**PLANNING COMMISSION AGENDA  
CITY OF PRAIRIE VILLAGE  
TUESDAY, JULY 1, 2025  
7700 MISSION ROAD  
COUNCIL CHAMBERS  
6:00 P.M.**

## STAFF REPORT

**Application:** PC 25-07

**Request:** Building Line Modification

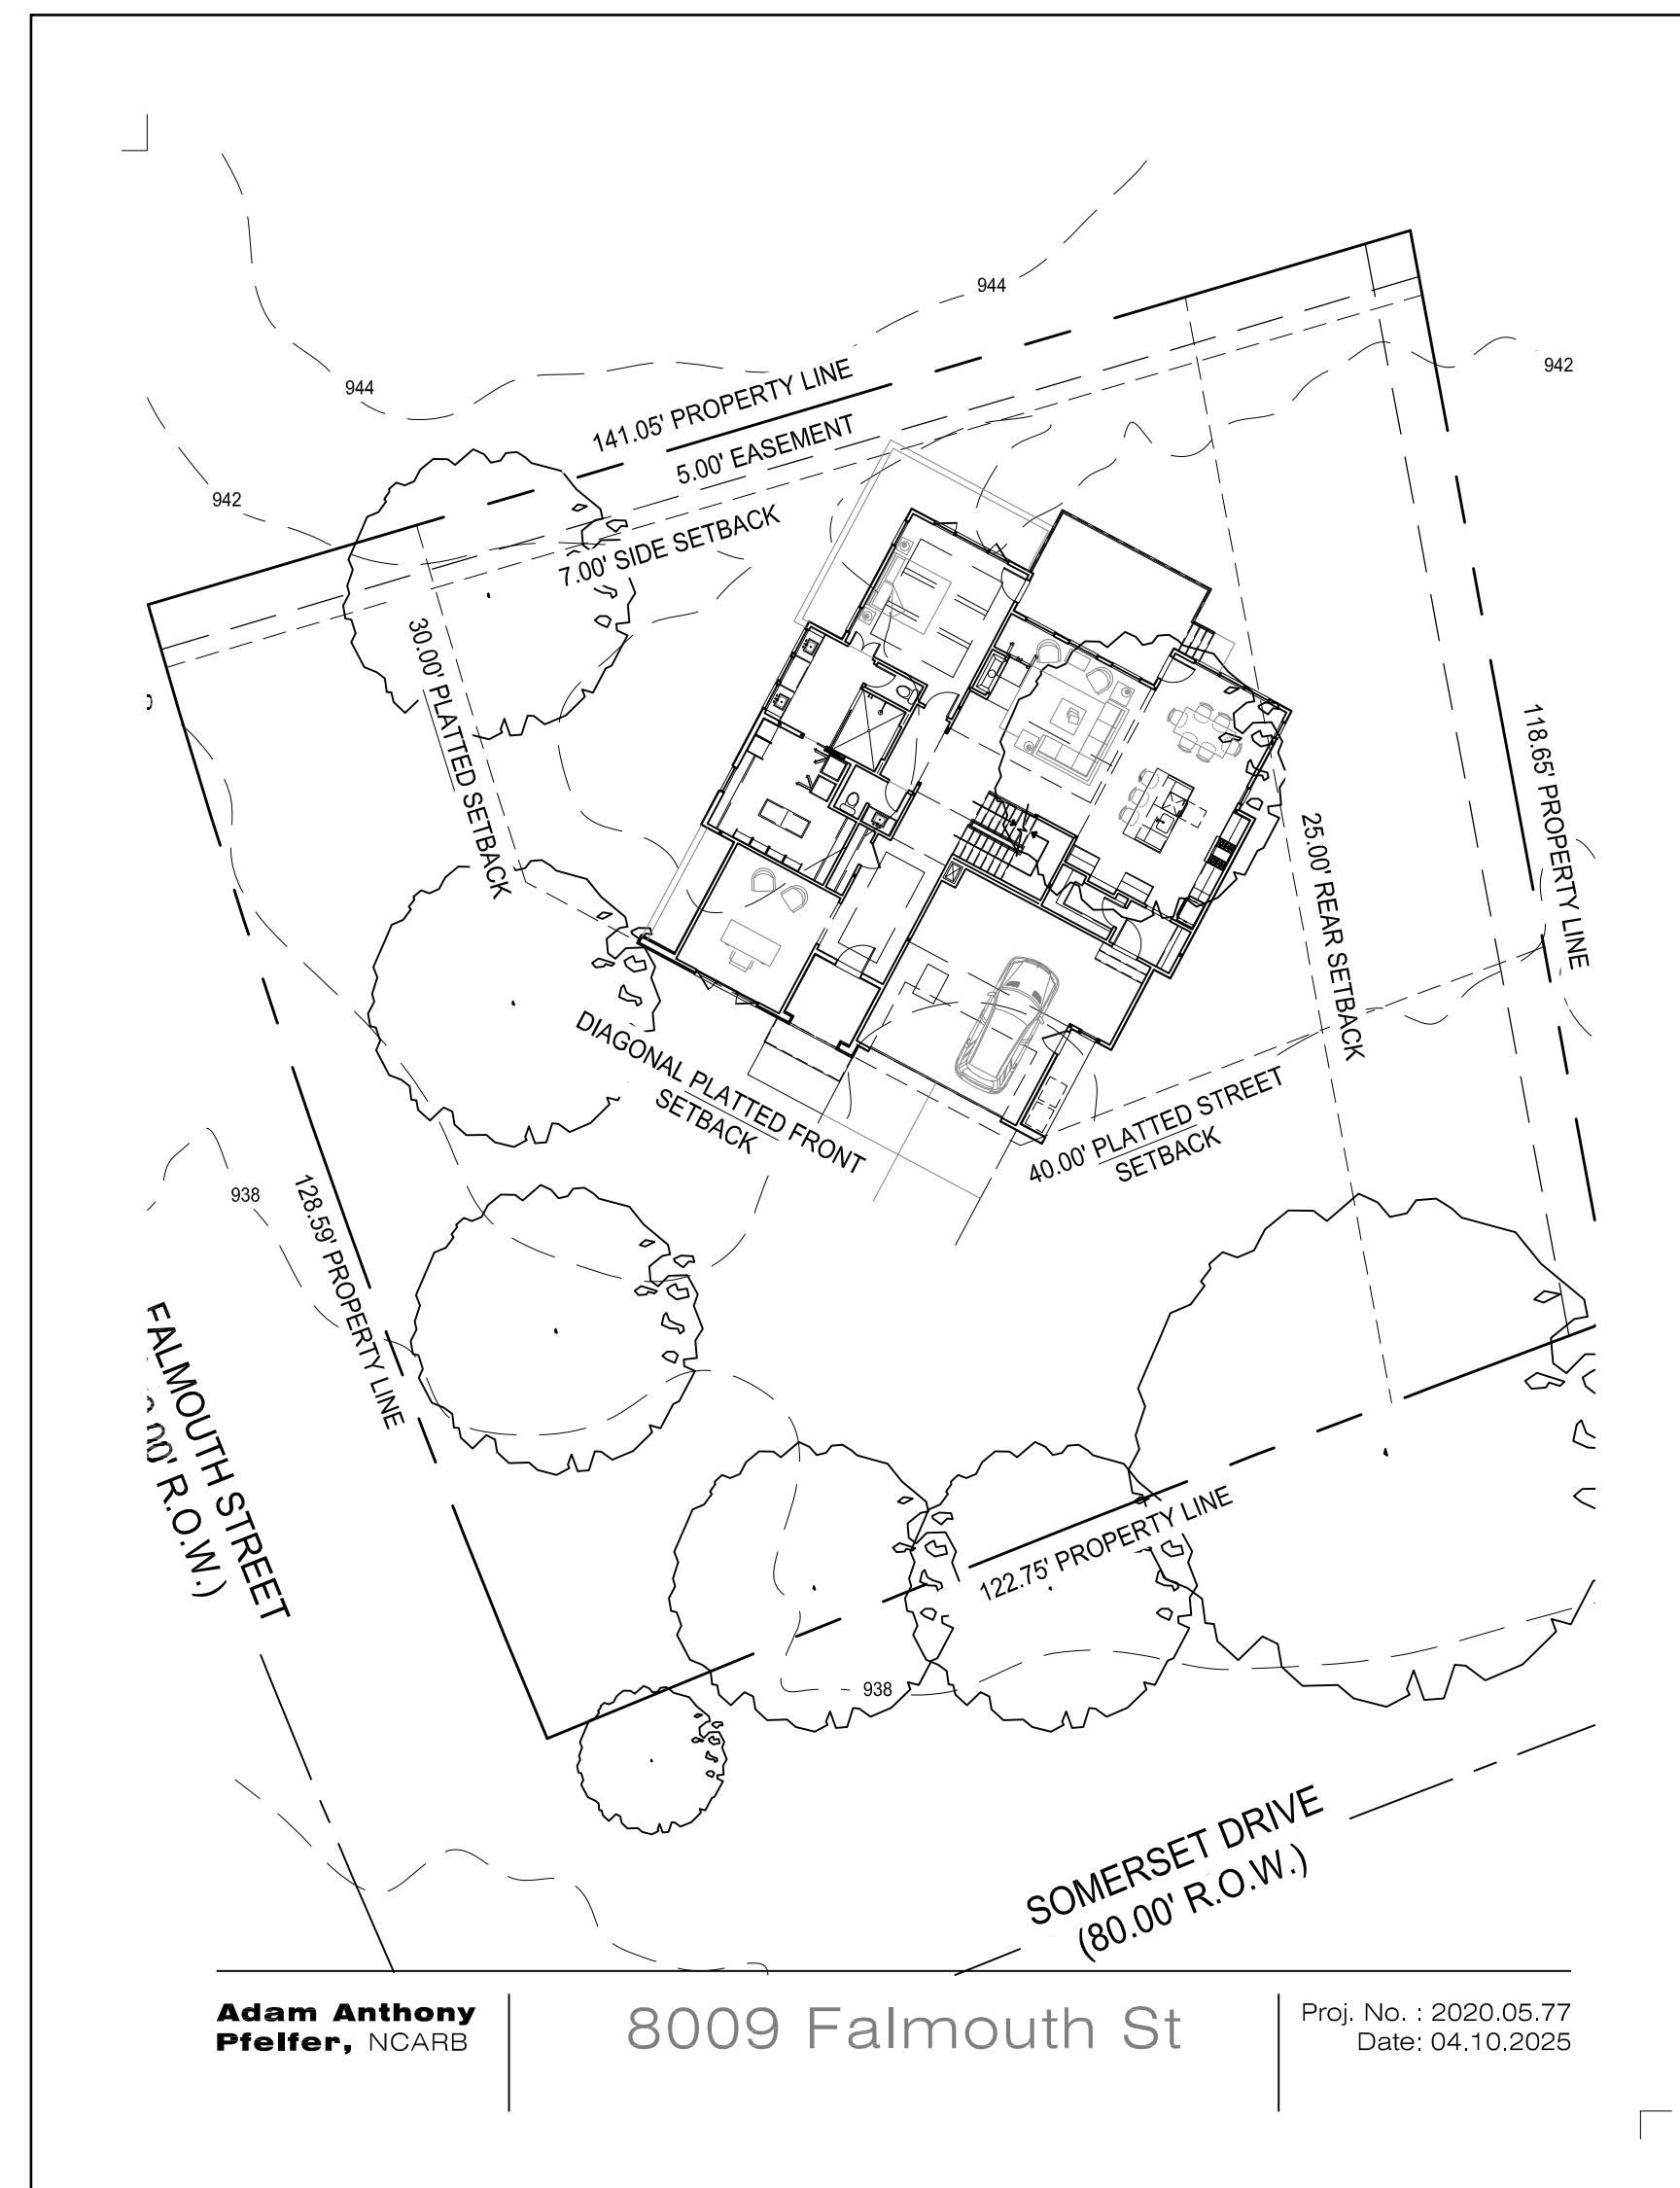
This configuration is allowed per 19.44.020. - YARD EXCEPTIONS. (e)In R-1a and R-1b, when applying the development and design standards, the building official may determine corner lots be oriented as follows, based on any prevailing patterns of the adjacent lots and blocks:(1)Standard corner. The building orients to the same front as all other buildings along the same street and the front setback and design standards apply to this street. The expanded street side setback applies to the other street, the side and rear setbacks apply to the remaining sides.(2)Reverse corner. The building orients to the short side of the block, different from other lots on the interior of the block, and the front setback and design standards apply to this street. The expanded side setback applies to the other street and the side and rear setbacks apply to the remaining sides.(3)Intersection orientation. The building orients to both streets and the front setback and design standards apply to each street. The interior side setbacks apply to both abutting lot sides, and no rear yard setback applies.

(3)Intersection orientation. The building orients to both streets and the front setback and design standards apply to each street. The interior side setbacks apply to both abutting lot sides, and no rear yard setback applies. This configuration does not require Planning commission approval it is already allowed per the Prairie Village Zoning code

REVISIONS	SHEET NUMBER	SP1	SITE PLAN
REVISION 5/5/2025			
ISSUE DATE			
04.26.24

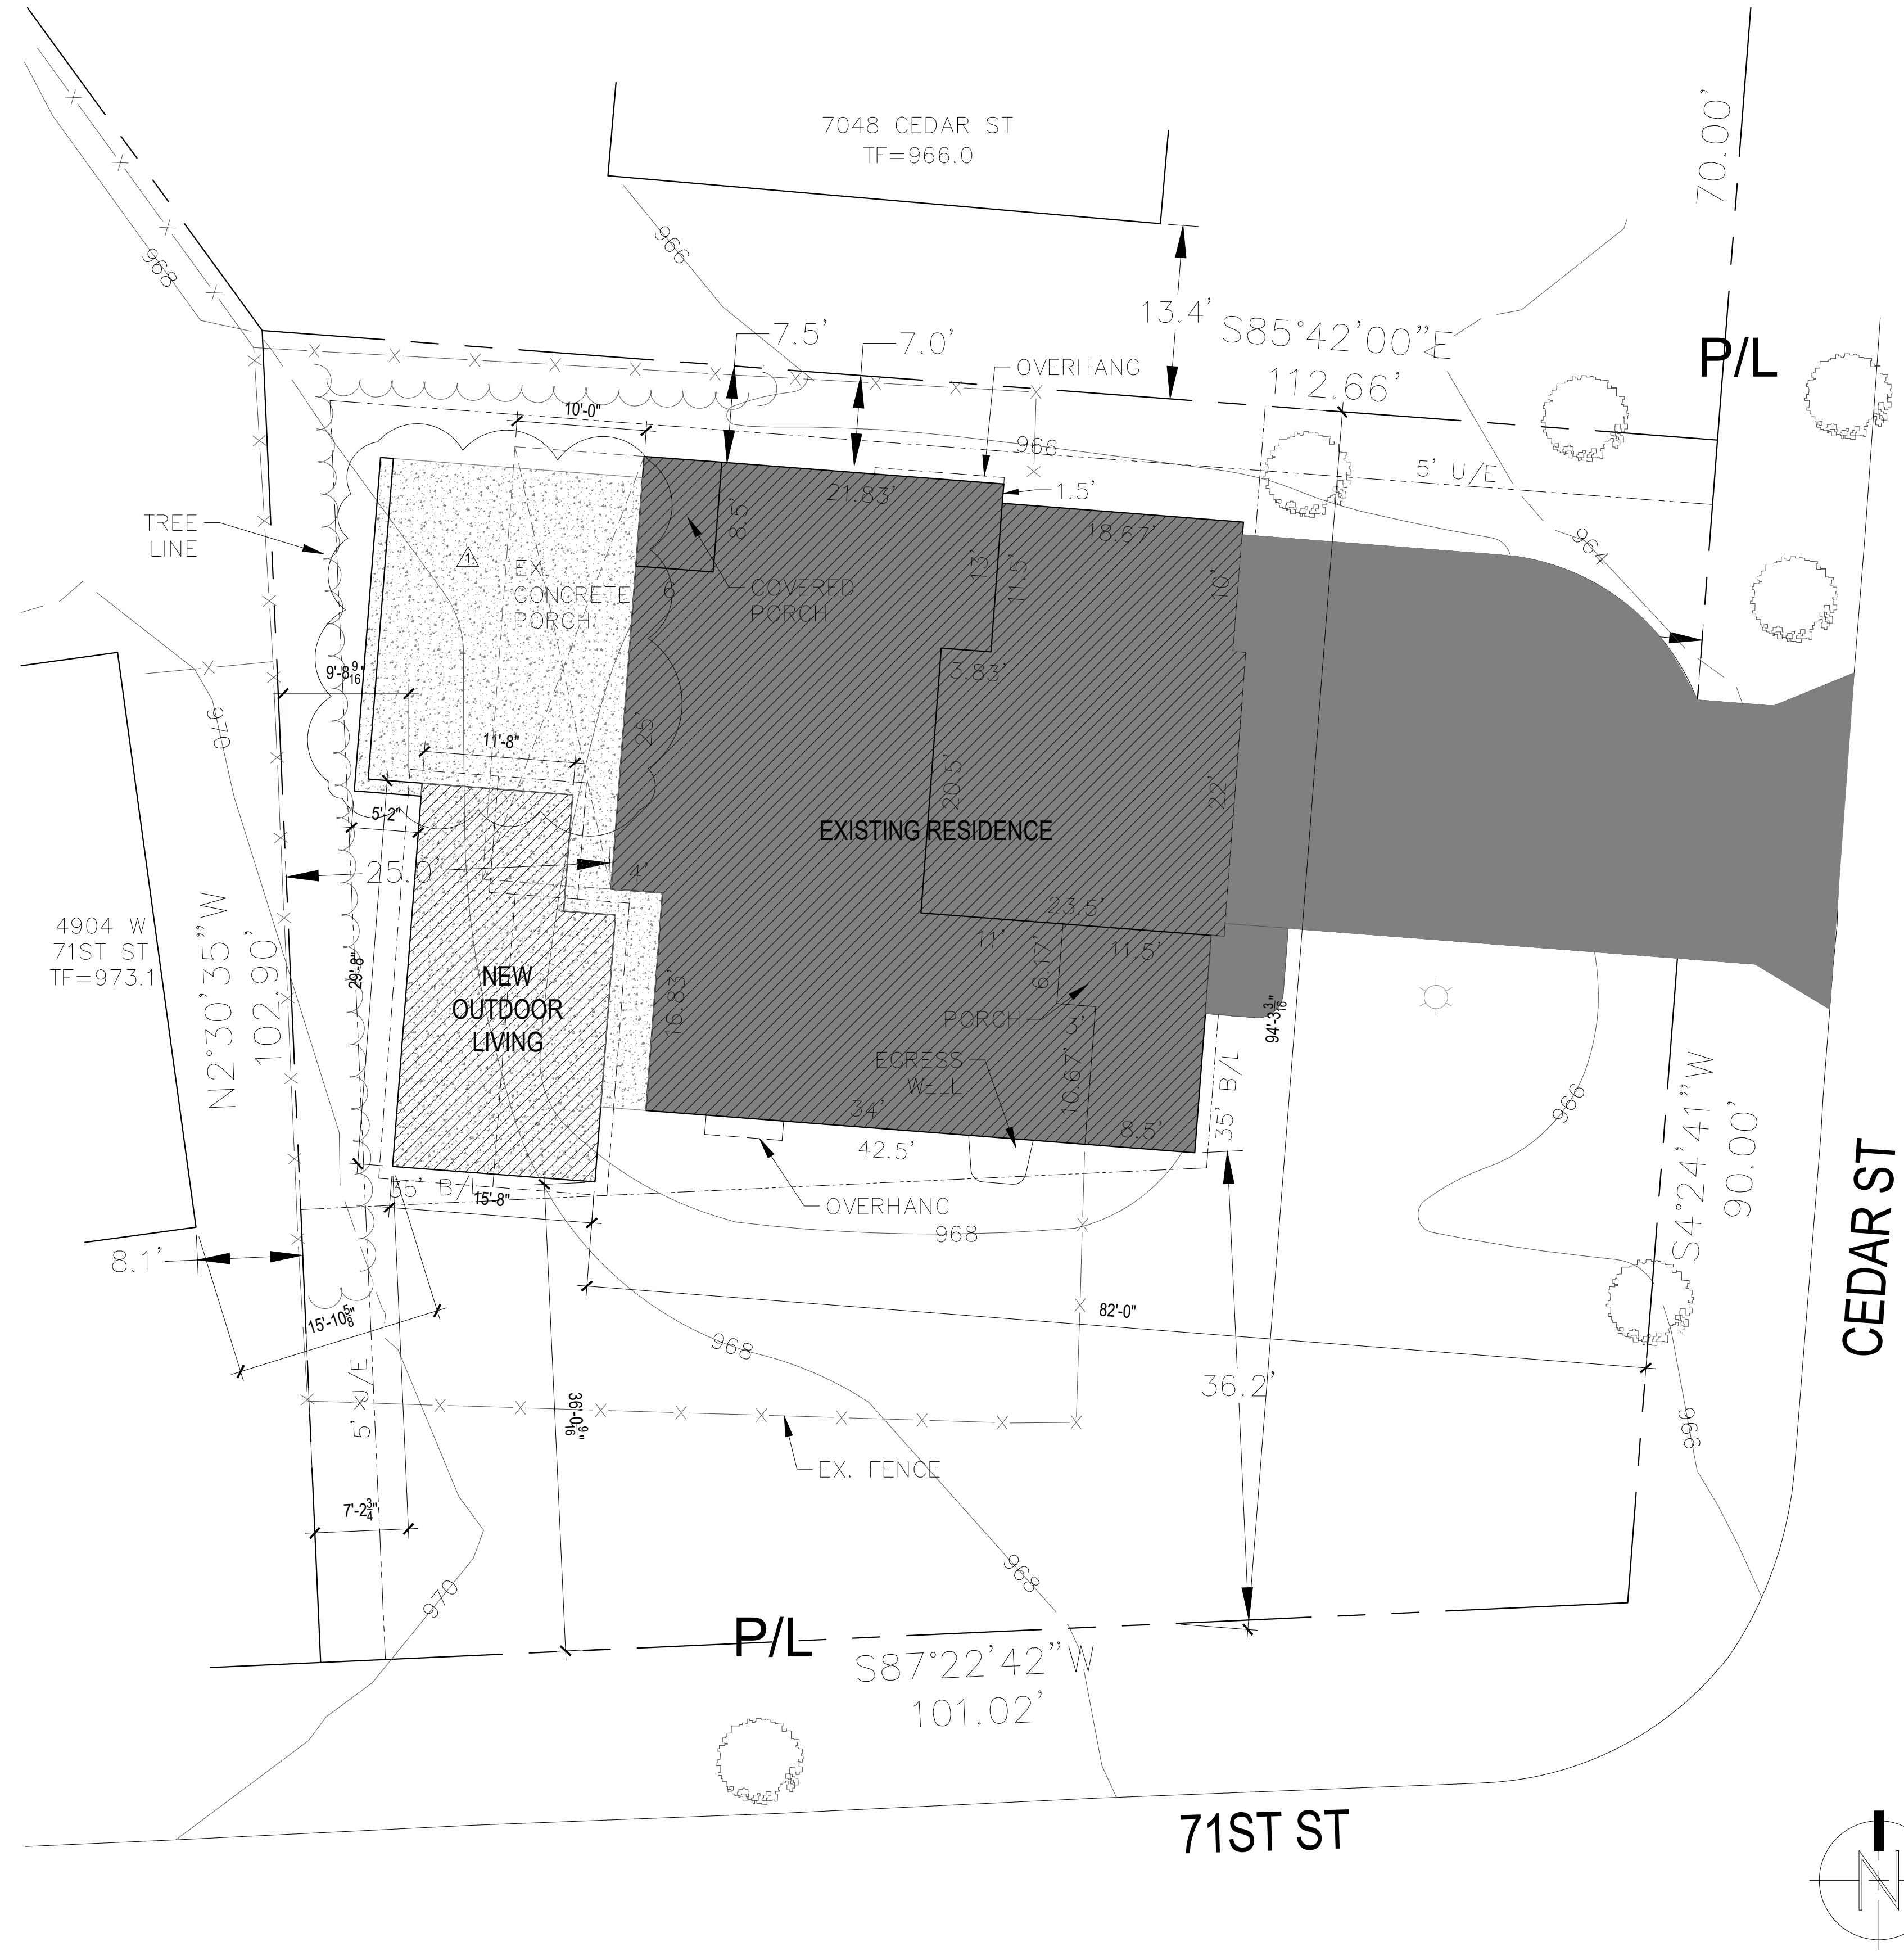
*This application meets all standards other than the 40% impervious coverage standard. The impervious coverage standards anticipated circumstances similar to this application and include a specific process and criteria for the Planning Commission to consider exceptions. There are no other planning, design or public health, safety, or welfare issues impacted by this application, other than the stormwater issues analyzed in B. below and the landscape / adjacent property relationships analyzed in D. below.*

*This site is currently served by streets and utilities, and this plan does not affect any access or utility issues. The applicant submitted a drainage study to support the updated application and exception request. Public Works has reviewed the study and is okay with the impervious area. The layout conforms to the original drainage study intent and does not impact adjacent properties. Runoff flows to Cedar Street via a side yard swale on the north side and flows south to 71<sup>st</sup> Street on the south side.*

- The limited nature of the exception (approximately 2.3% or 237 s.f. from the standard) and the negligible impact it will have on overall stormwater policies for the City.
- Public Works has reviewed a drainage permit for the project and does not believe the proposed plan will cause drainage issues on adjacent property and will not negatively impact public stormwater management.
- The property is a corner lot with large frontages on both the east and south sides, leaving a smaller back yard with little utility; a constructed formal patio and outdoor gathering space allows for better utilization of this area. The design is proposed in a way that has little impact on adjacent properties.
